Technical Bulletin

| Subject: Firmware Release Note: Finisher_COLUMBIA | | | Prepared by: T. Tadokoro | |

| Model: B-C4 | | | Date: 06-Apl-09 | | 09 | No.: RD059019 |
|---|---|---------------------------------|-----------------|-------------------------|----|-------------------------------------|
| Subject: Booklet Finisher SR5020 staple position adjustment | | | | Prepared by: T.Tadokoro | | |

Model: Booklet Finisher SR5020

SP Mode : SP6208

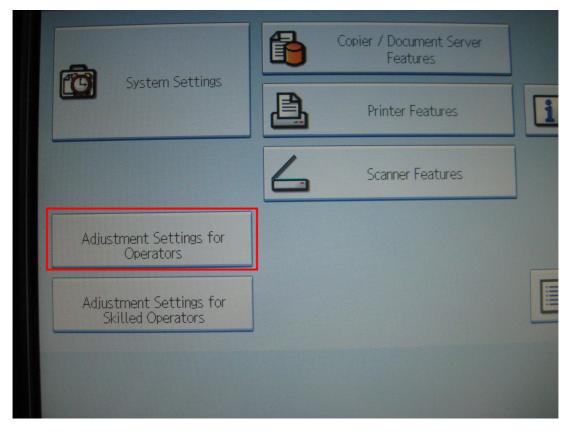
Staple positioning could be misaligned on the SR5020 when stapling 2-4 sheets in "rearoblique" mode with a paper size of A4 short-edge feed or smaller.

Misaligned stapling is caused by the shifting of the stacked paper when the stapler clinches. A portion of the trailing edge of the stack of paper interferes with (is caught by) the Jogger Spring Plate as it is bent when jogged by the Spring, which causes the shift.

If this problem is reported from the field, please follow the instructions of SP 6208 or Adjustment Settings for Operators.

33.Shift Tray 3 (D434)

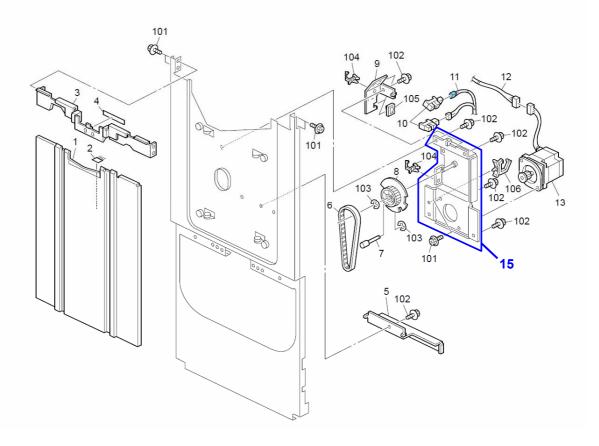
Change: A new service part has been added.

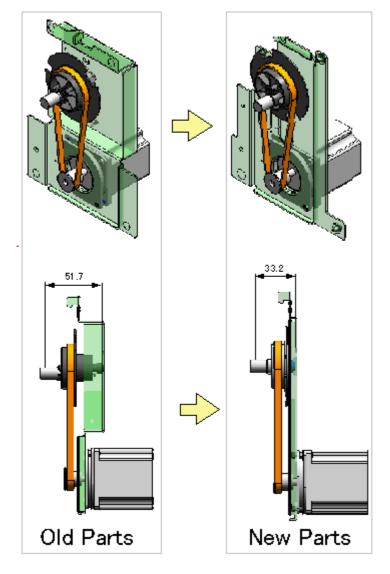
Failure occurs in the tray shift behavior when exceeding 2500 outputs to the shift tray when applying paper types that are relatively heavy considering the thickness such as coated paper.

Excess load to the component causes the timing belt and the gear to disengage.

Replace with the modified parts described in the table below.

Refer to Fig. 1 to identify whether the machine is installed with either old or new parts.

4.Paper Transfer:Entrance 2 (D434)

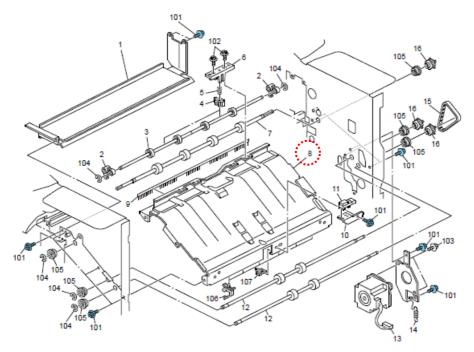
Change: A new part was added.

Reason: To prevent the leading edge of a Z-folded sheet from jamming **Please note this RTB only when the Booklet Finisher SR5020 is used in combination** with the Z-folding function.

The leading edge of a Z-folded sheet could jam with the entrance guide plate of the Booklet Finisher SR5020. Mylar (p/n D4342135) has been added to the entrance guide plate (p/n D4342131; indexed 8 below) to lower the chances of jams and allow smooth entrance of the leading edge.

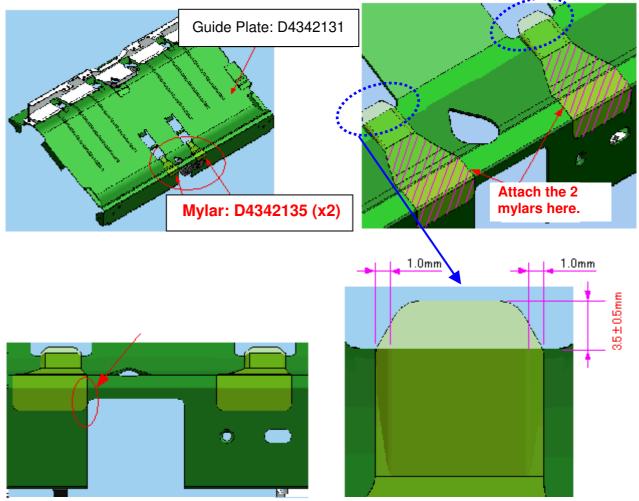
The diagrams below describe how and where to attach the mylars.

Align the edge of the mylar against the edge of the cutout.

Attach the mylar so that the tapered area of the bracket is covered entirely.

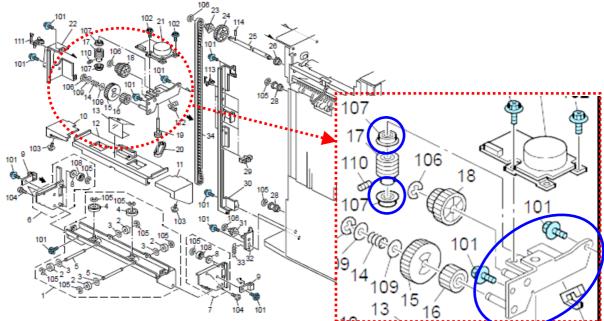
Change: Ball bearing (in the shift tray drive) **Beason:** Higher reliability

The shape of the bracket has changed accordingly with this modification.

- The modified ball bearing (07413506) cannot be installed in the old bracket.
- This modification is reflected in the production starting from June 2010.

16.Staple Unit 6 (D434)

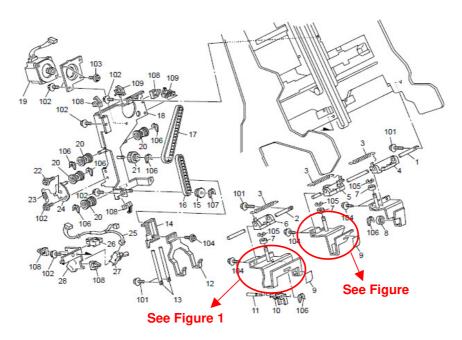
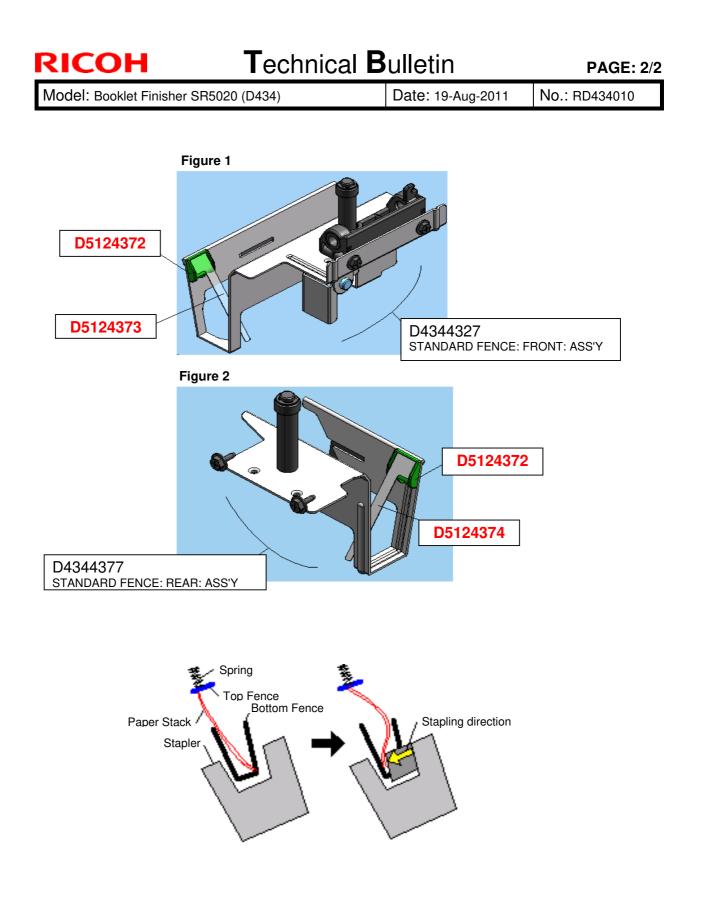
Change: Addition of Mylars to the bottom fences **Reason:** Higher stapling performance

Mylars have been added to the bottom fences (front and rear) to prevent the stacks from bending, which could result in inaccurate stapling.

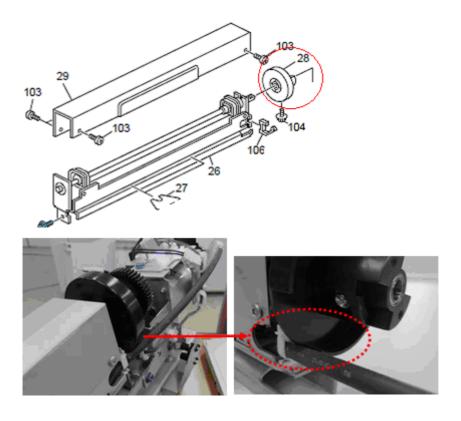
Frequent SC760 (Punch Motor Error) / SC762 (Punch Switch Motor Error)

Harness cable of the punch unit is set incorrectly and is interfering with the ratchet (indexed 28), preventing the ratchet from retrieving its home position.

29.Paper Exit Section 2 (D434)

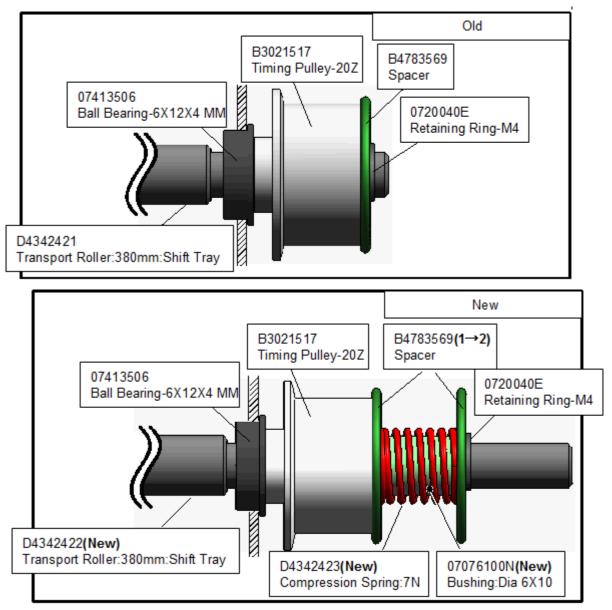
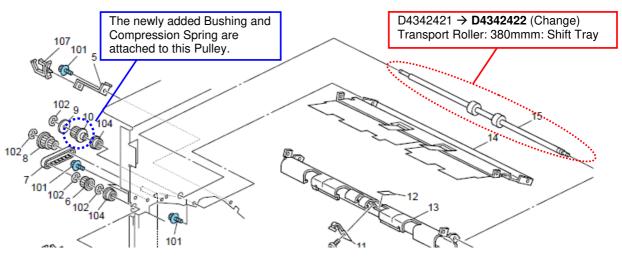
Change: Addition of a spacer to the timing pulley

Reason: To prevent possible toner offset contamination on the edge of the paper caused by the timing pulley

When replacing the above parts, replace as a set together with the following part. B4783569: Spacer (Q'ty 1)

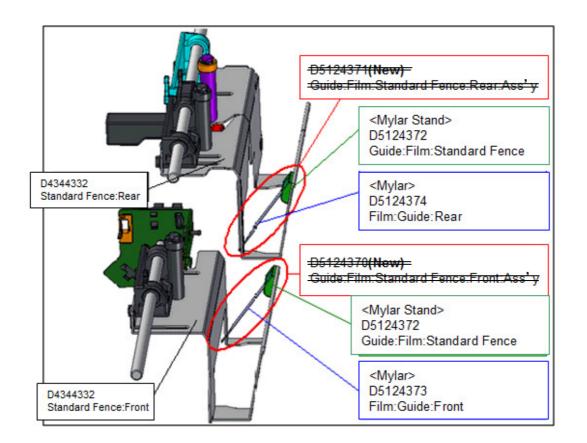
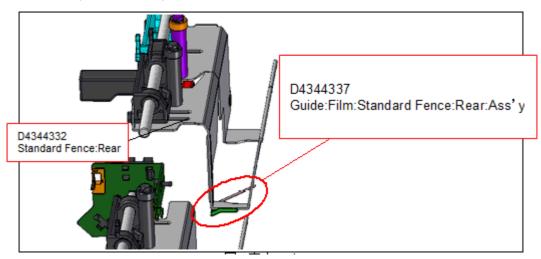
- **Change:** Mylars attached to the staple fences to enable higher stapling accuracy were registered as assembly service part.
- **Reason:** To enable easy attachment of the above part when encountering peer stapling issues
- Model : Booklet Finisher SR5020 (D434)

The staple fence will be installed with the Stand and the Mylar from April 2012 mass production. If poor stapling occurs in the original units (which are installed with staple guides that appear as shown in the diagram below) due to slack in the staple stack, procure the newly registered assembly parts D5124371 and D5124370. procure D5124372, D5124373, and D5124374.

Shift tray base plate

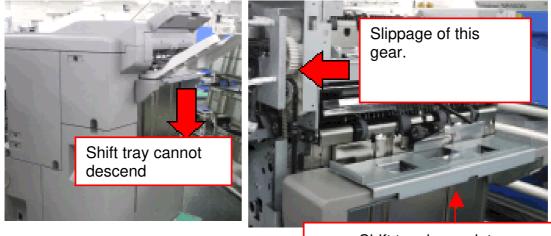
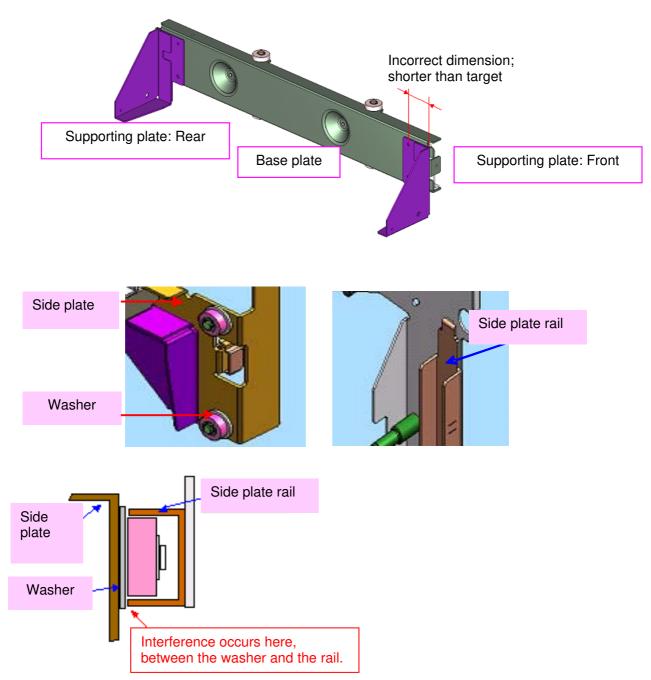
The system exhibits all of the following 3 symptoms:

- SC750
- Shift tray cannot descend
- Slippage of the shift tray gear

The front and rear supporting plates, which are bent and welded to the base plate, were bent in incorrect dimensions due to a fault in the manufacturing process. This causes the washer installed on the side plate to interfere with the side plate rail, preventing the shift tray from descending.
